“The Sheffield Plan”

Review of Proposed Junction for Site CH04 ‘Hesley Wood, North of Cowley Hill, S35 2YH’

April 2026

Site Illustration, Annotated to Show Proposed Site Access – Spawforth

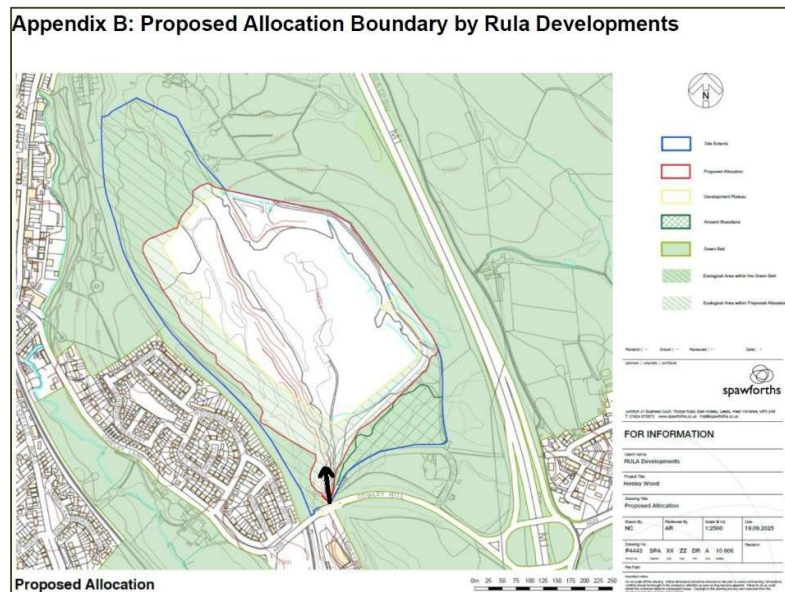
The proposed site access is directly opposite the signalised Cowley Way junction, itself regularly saturated. Introducing a new access serving a modern employment or logistics use, likely to generate significant HGV, LGV and car movements, would add conflicting traffic demands at a critical point in the network. At present, no detailed or proven mitigation strategy has been demonstrated to show that these impacts could be reduced to an acceptable level, particularly on the local highway network downstream of the M1.

Arrow Shows Proposed Access Point – Spawforth Illustration Annotated

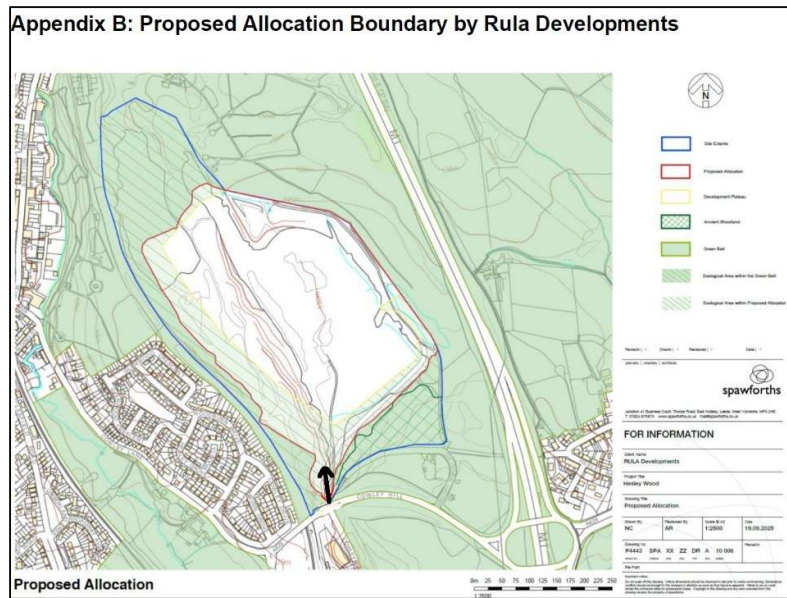
The proposed CH04 site access is opposite Cowley Way, a signalised junction. As mentioned the junction is less than 500 metres from the M1. The junction is regularly gridlocked and an additional access here would be sure to add to congestion especially with high HGV and LGV numbers, and the absence of realistic sustainable travel alternatives to the private car. This is discussed later under Sustainability.

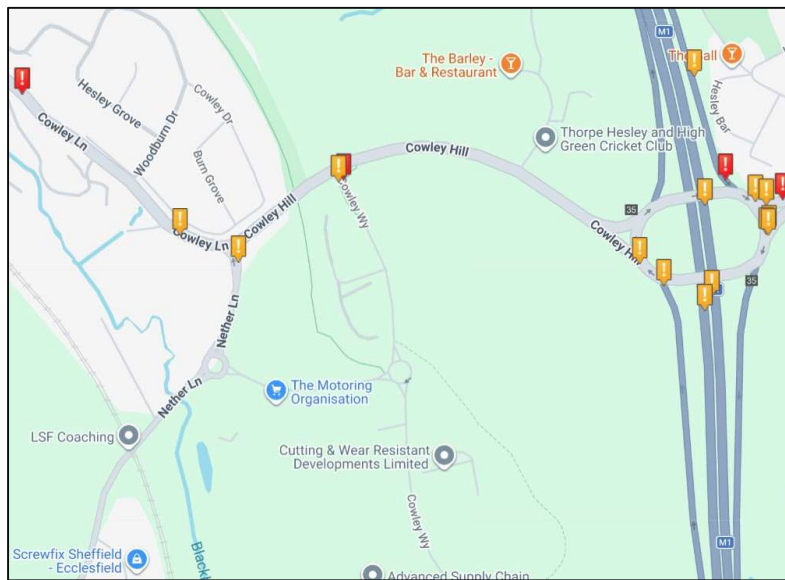
Aprica does not have the software or expertise to challenge TRICS (Trip Rate Information Computer System) and to do so would take many hours. It is therefore beyond the remit of this report but the core issue for Site CH04 seems to be the discrepancy between the theoretical model used by SCC and the physical reality of modern logistics. Objectors have argued, in earlier consultations, that SCC has "under-counted" the traffic impacts. This would make the site appear more sustainable than it actually is. TRICS' accuracy is, as described above, based on analysts and Planners picking 'comparable' sites to predict how much and what type of traffic a new one would create. For this specific site critics have argued that SCC has taken 'traditional warehousing' or 'general Industrial' examples whereas site CH04 is more likely to constitute a logistics hub, which would generate significantly higher HGV and LGV movements. By using an inappropriate category the projected vehicle numbers could well be too low.

In addition, choosing a 'dissimilar' existing example could skew projected sustainable travel figures. Site CH04 is on a relatively steep, semi-rural edge with limited walking and no real cycling facilities, and inconvenient out of date bus facilities. Using such dissimilar samples constitutes data error. If traditional 8am to 5pm patterns have been used, again this would skew traffic volumes and modes.
